NOTICE TO ALL CONTRACTORS:

Official Notice 27-2013: Rehabilitation of the St. Paul Avenue Lift Bridge over the Milwaukee River

This is Addendum No. 2, which provides for the following:

SHEET S20 OF S60 – PIER 3 COLUMN RECONSTRUCTION

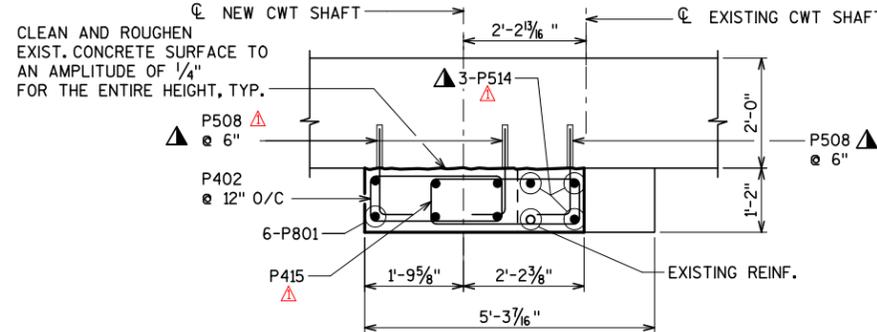
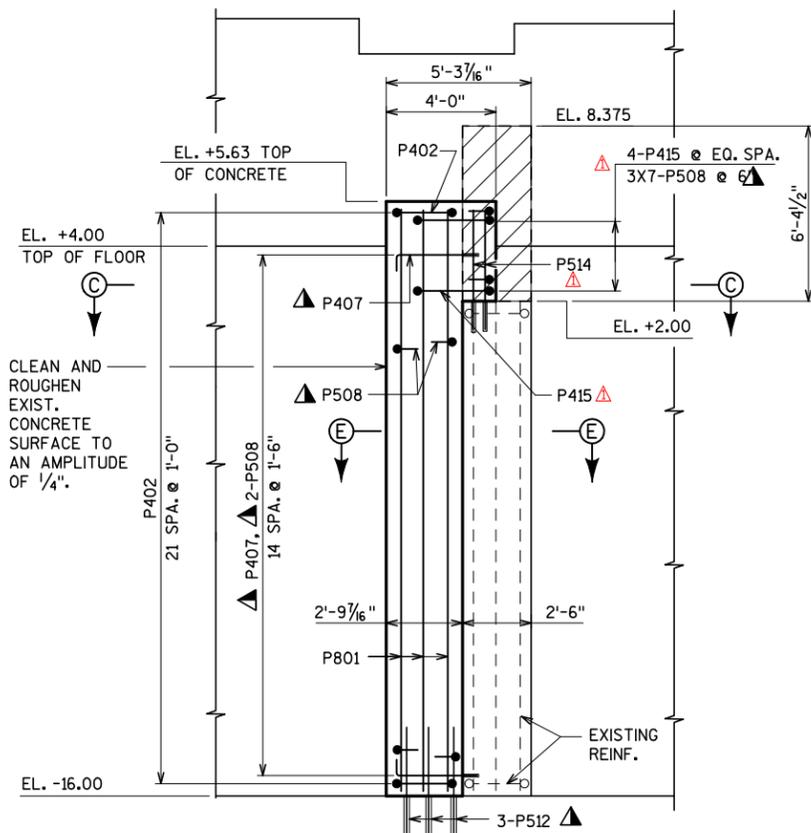
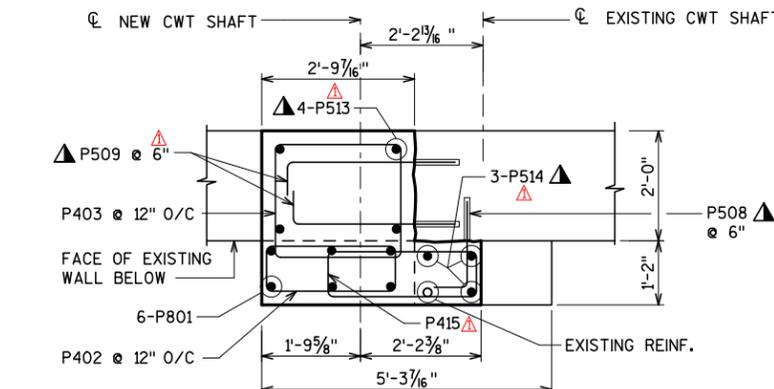
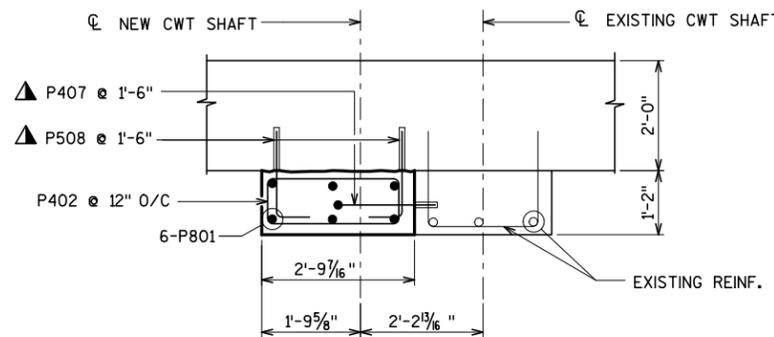
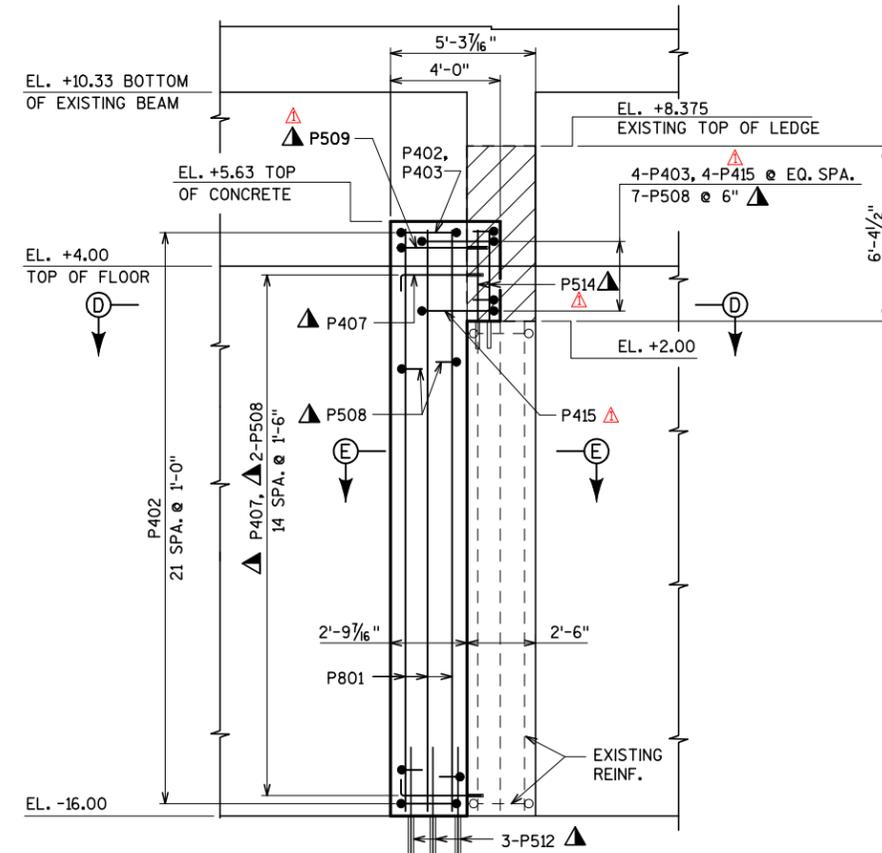
Updated Bar Marks and Bar Spacing on “SECTION C-C,” “SECTION D-D,” “VIEW G-G,” and “VIEW F-F.”

SHEET S40 of S60 – DIAPHRAGM REINFORCEMENT DETAILS

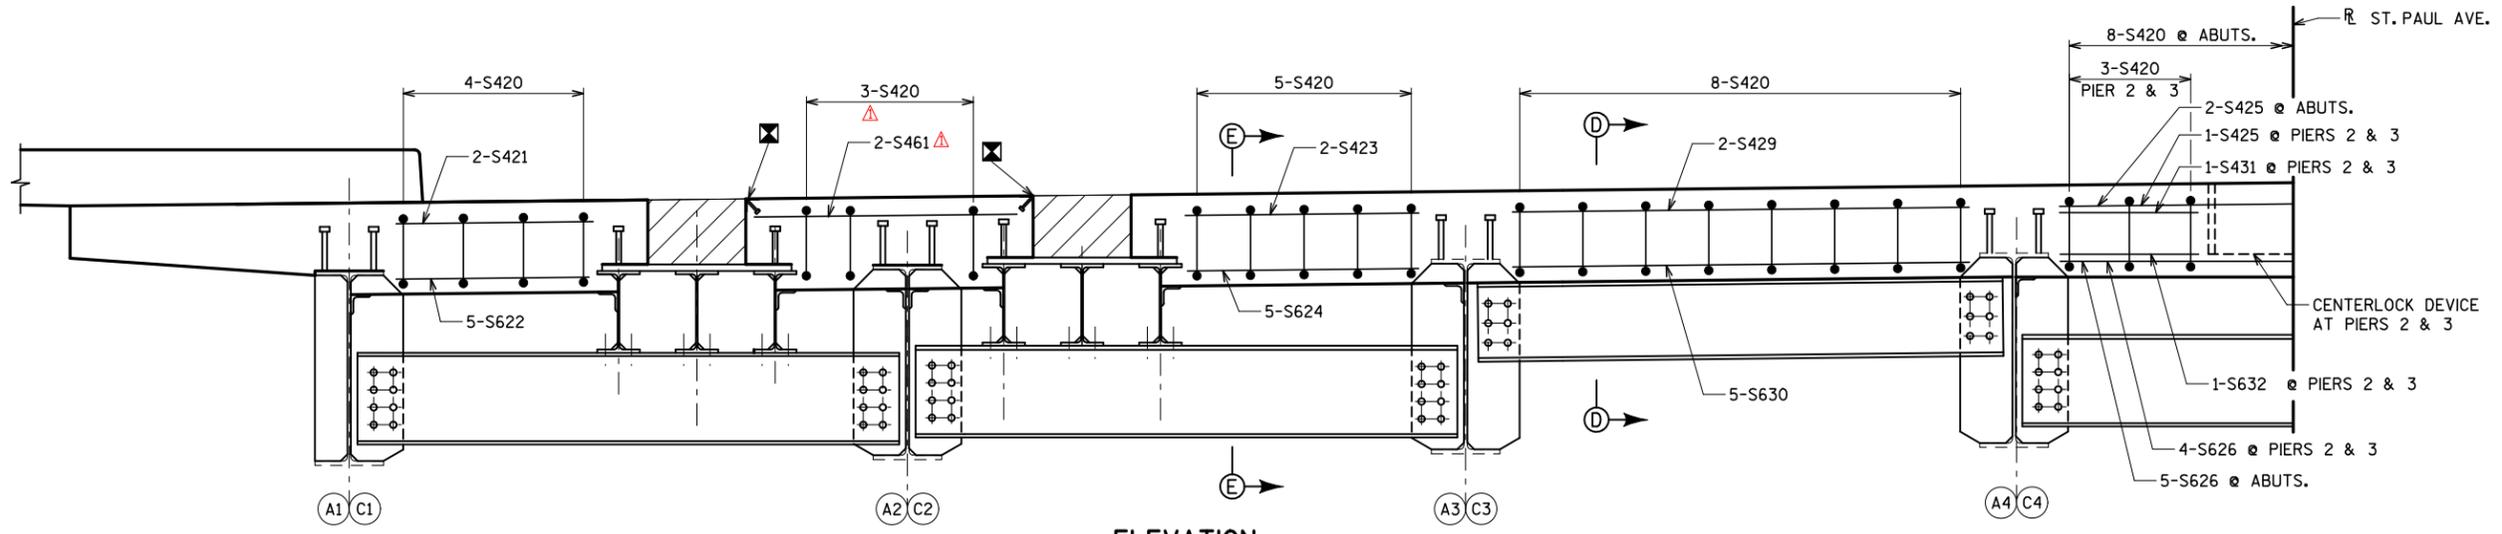
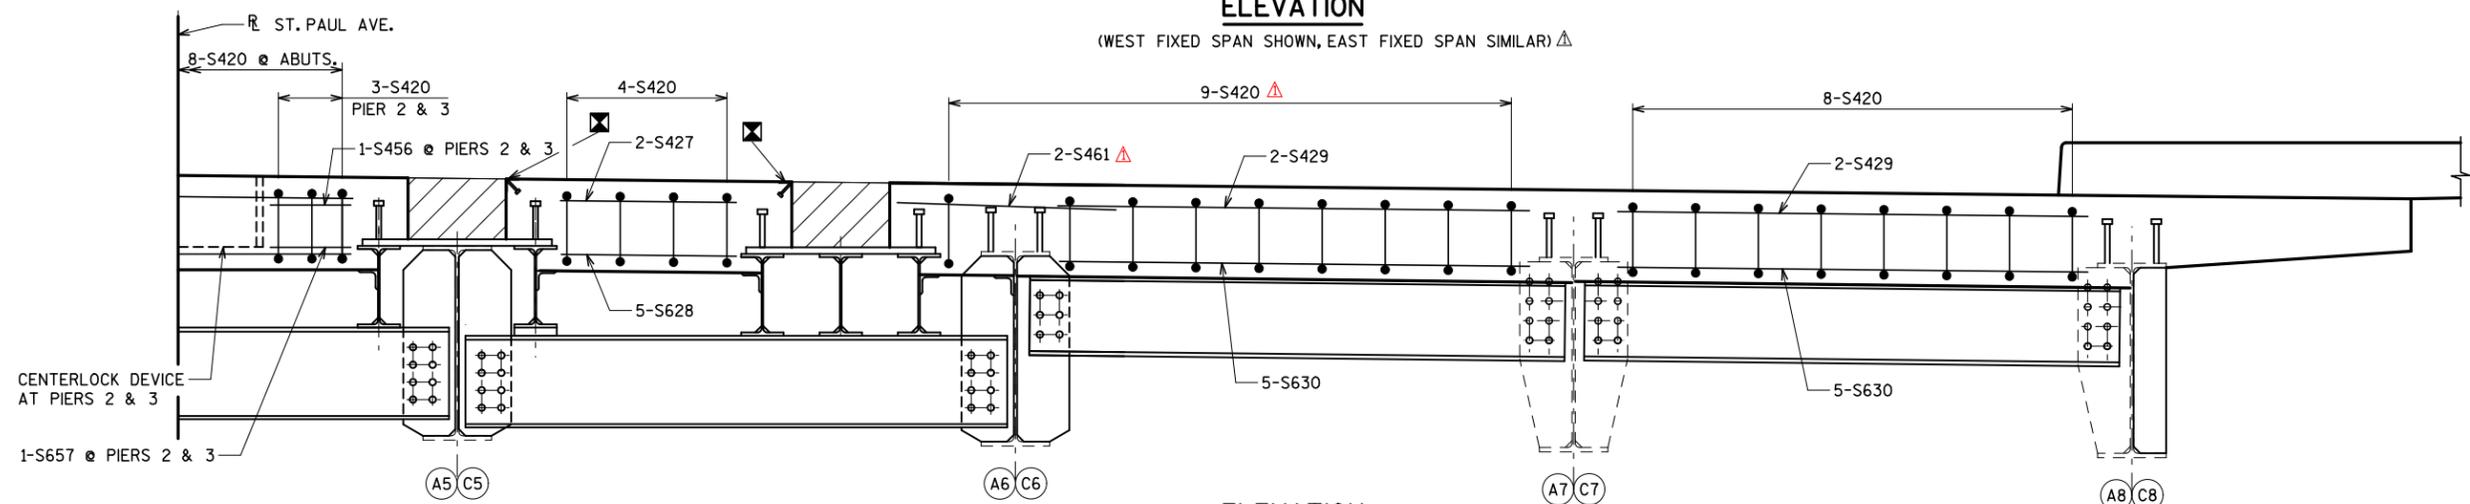
Updated Number of Required Bars and Bar Numbers in Multiple Location on Each “ELEVATION” view.

SHEET S43 OF S60 – FIXED SPAN EXPANSION JOINT DETAILS

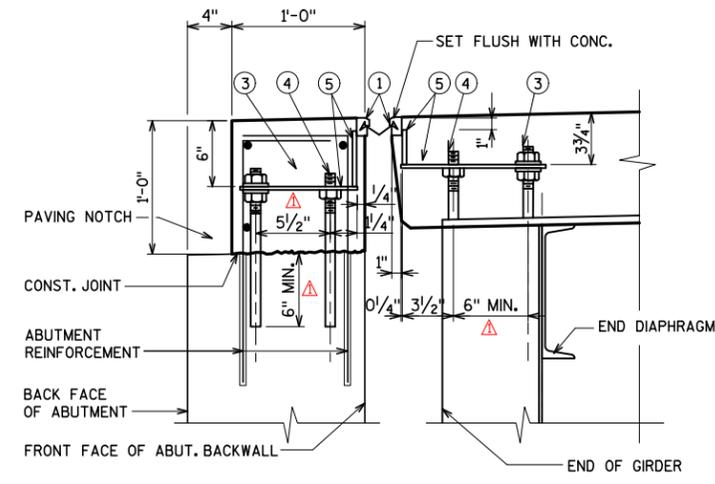
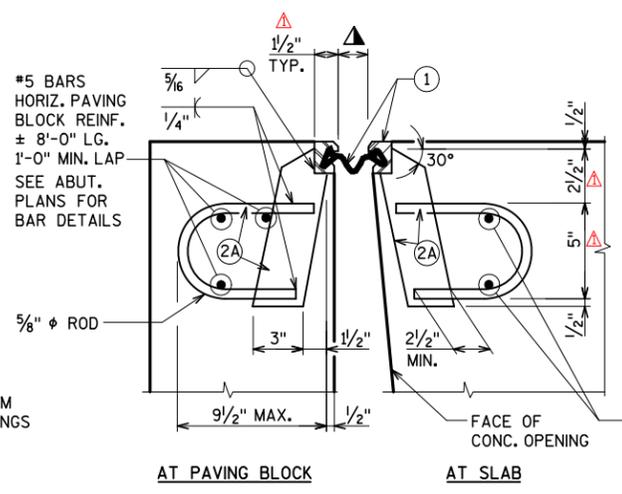
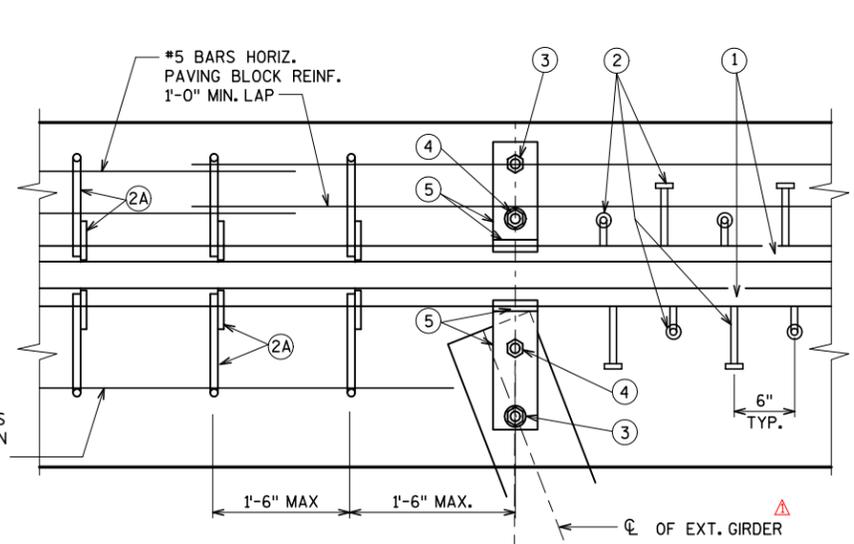
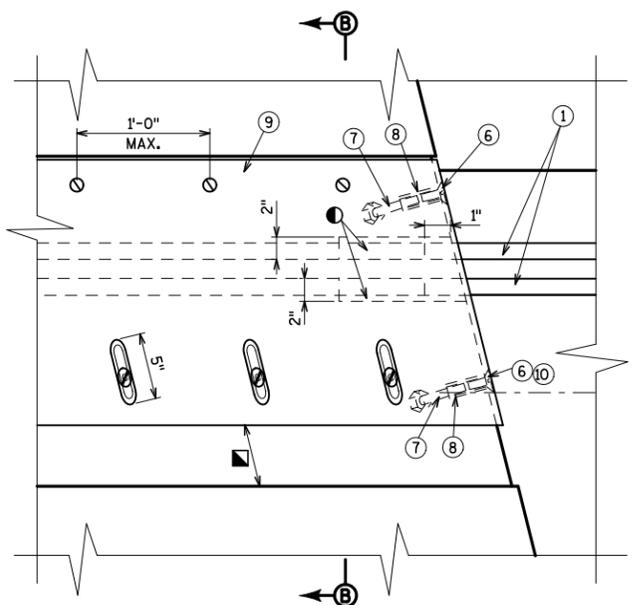
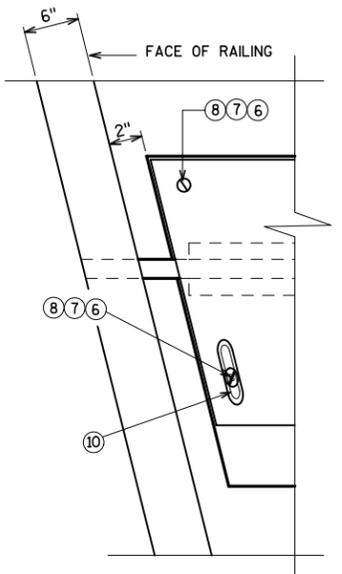
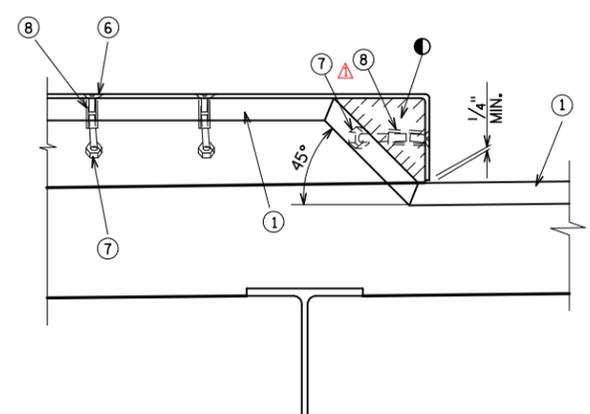
Updated dimensions and notes in all “SECTION THRU JOINT” details, “PART PLAN,” “SECTION B-B,” and “SECTION AT SIDEWALK.”

CANTILEVER BRACKET- ELEVATION

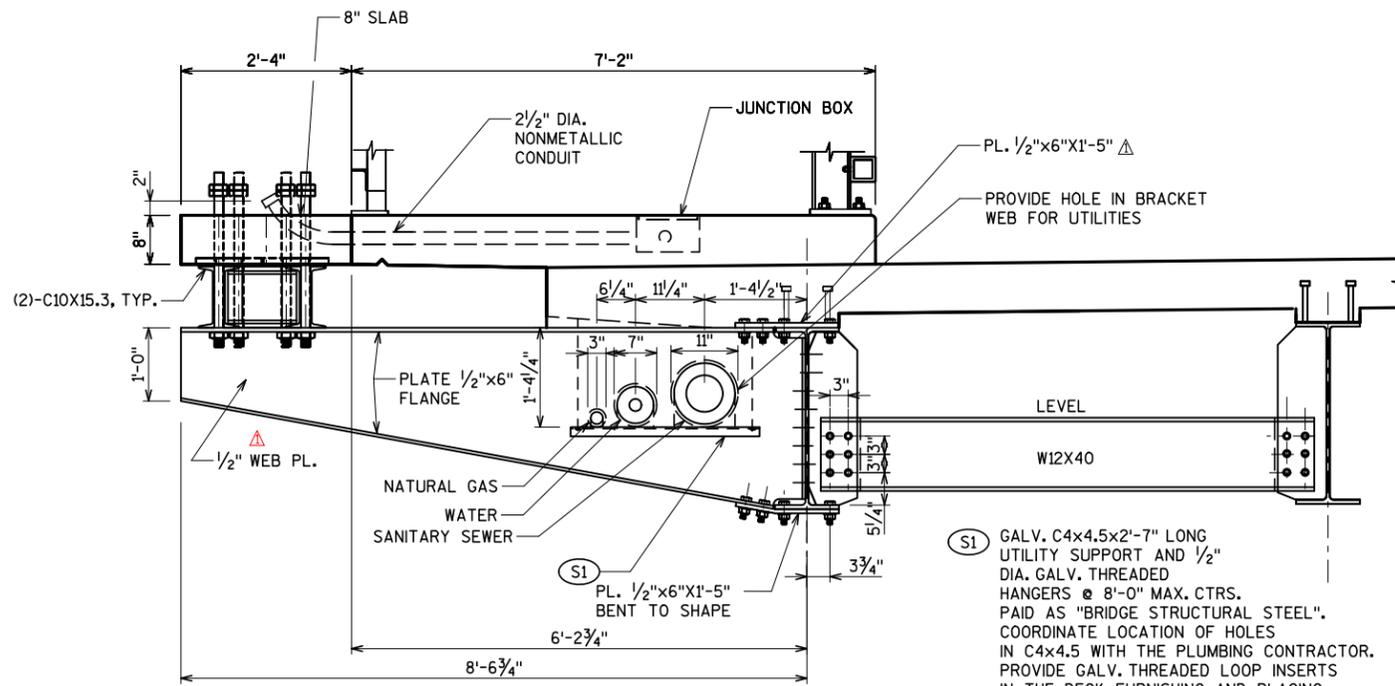
Added note for web thickness to detail of “CANTILEVER BRACKET – ELEVATION”

SHEET S51 OF S60 – PIER 2 ELECTRICAL PLATFORM

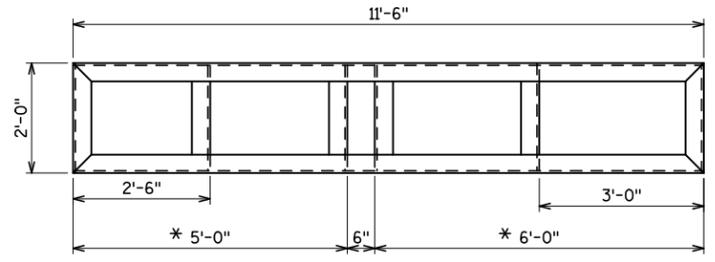
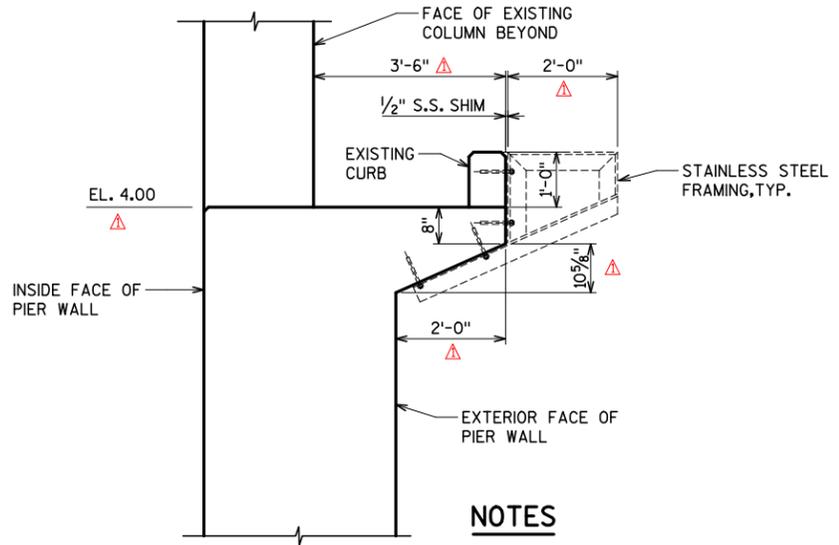
Updated Dimensions and Elevations on details “TYPICAL STAINLESS STEEL BRACKET” and “SECTION A-A.”
